# 1997 - 1998 Corvette: Service Bulletin: Hiss Type Noise Coming From Weatherstrip When Closing Right or Left Door

**Subject:** HISS TYPE NOISE COMING FROM WEATHERSTRIP WHEN CLOSING RIGHT AND/OR LEFT DOOR (ADD RELIEF HOLE)

**Number:** 83-15-07

**Models:** 1997-1998 Chevrolet Corvette Coupe and 1998 Chevrolet Corvette Convertible

**Figure 1**

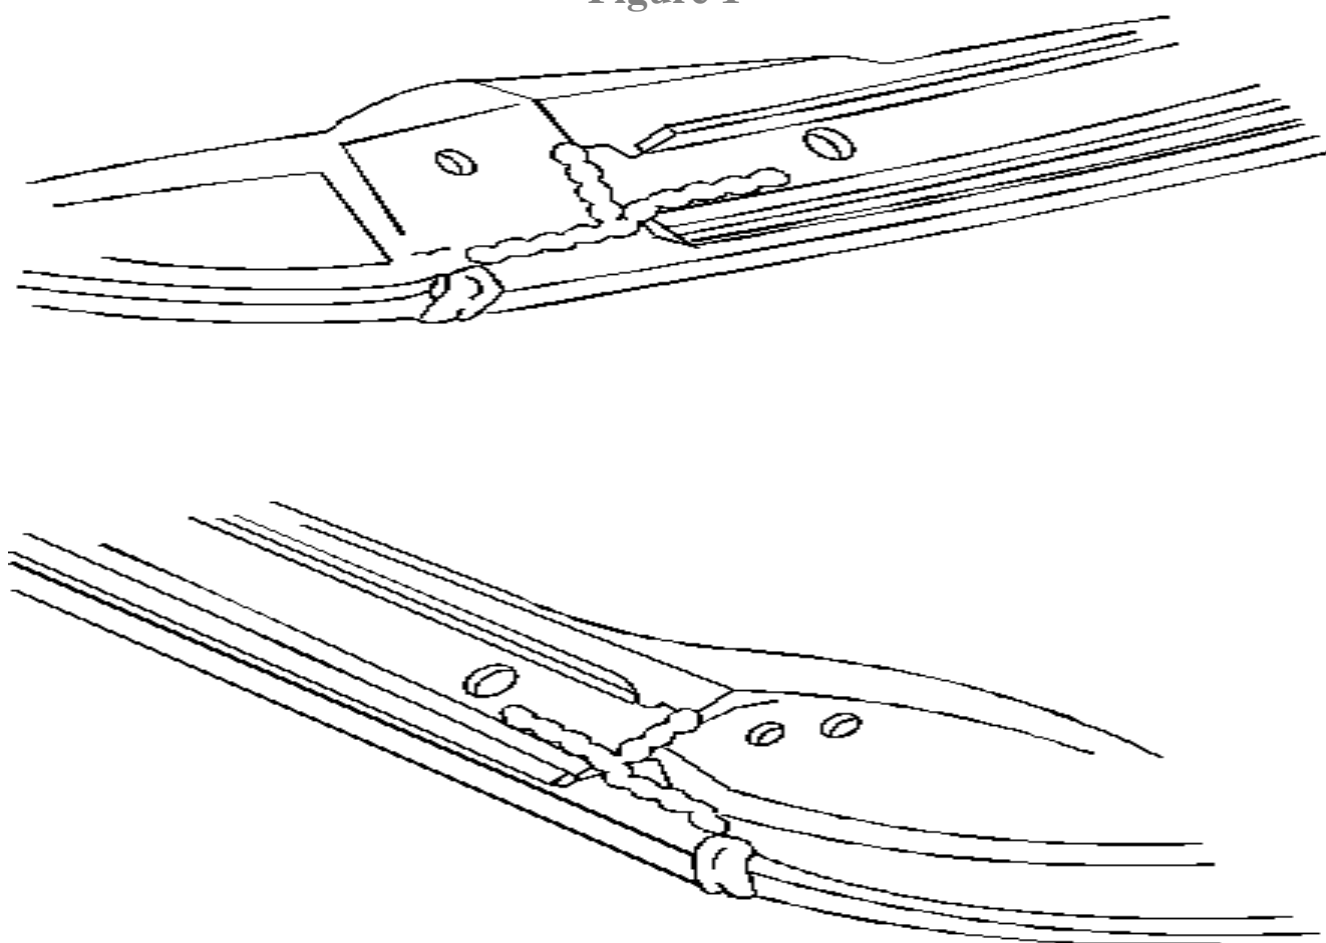
**Condition:** SOME CUSTOMERS MAY COMMENT ON A HISS TYPE NOISE COMING FROM THE WEATHERSTRIP WHEN CLOSING THE RIGHT AND/OR LEFT DOOR WITH THE GLASS IN THE FULL UP POSITION.

1. REMOVE THE WEATHERSTRIP ABOVE THE DOOR GLASS AND CUT AN AIR RELIEF HOLE 3MM WIDE (.12 IN) BY 10MM LONG (.4 IN) IN THE BACK OF THE WEATHERSTRIP.
2. RESEAL THE FRONT AND REAR CORNERS ON THE COUPE OR THE FRONT CORNER OF THE CONVERTIBLE WITH WEATHERSTRIP ADHESIVE; 3M(R) P/N 08011, OR EQUIVALENT. SEE FIGURE 1.
3. REINSTALL WEATHERSTRIP.
